# CITY OF SANTA FE

Buckman Direct Diversion

## INVITATION TO BID ITB # 23/74/B

**Title:** Granular Activated Carbon Media Changeout

**PARTIAL PLAN AREA C**  
 1/4"=1'-0"

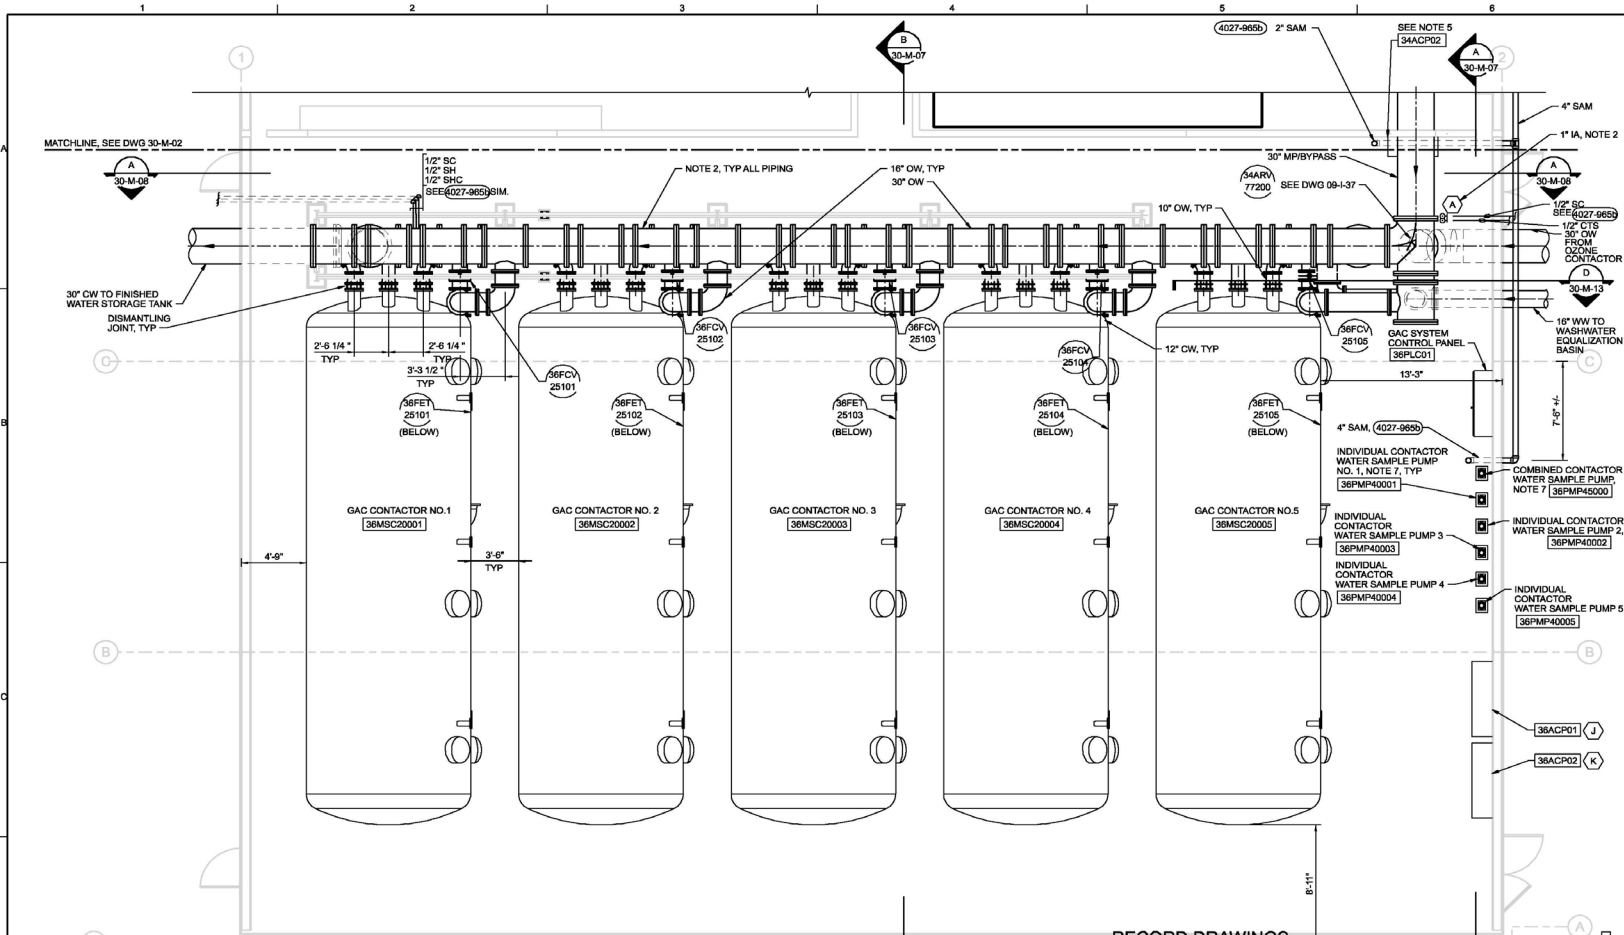
7) Can you provide more information on the contactors such as drawings or photos or any further description?

**Answer: Yes, we can provide photos and a description. See Attached Documents.**
